SHEARON HARRIS NUCLEAR POWER PLANT
NRC DOCKET NO. 50-400/OPERATING LICENSE NO. NPF-63
REQUEST FOR LICENSE AMENDMENT
PERFORMANCE BASED NUCLEAR ASSESSMENT PROGRAM

MARKED-UP TECHNICAL SPECIFICATION PAGES

6.2.3 PROJECT ASSESSMENT (PA) SECTION Deleted

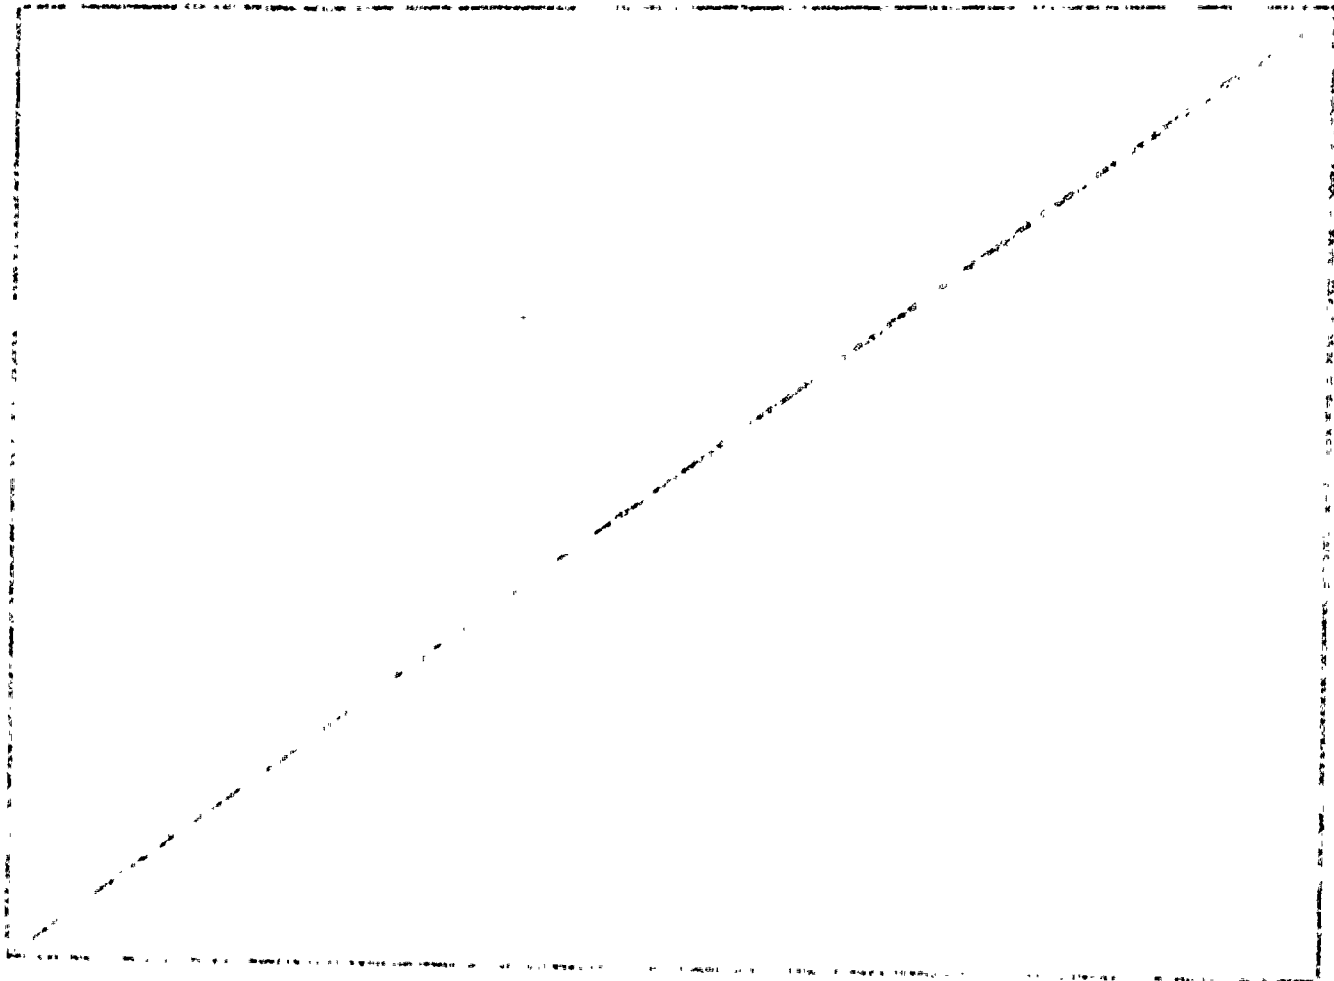
Delete (applicable to the deleted material above)
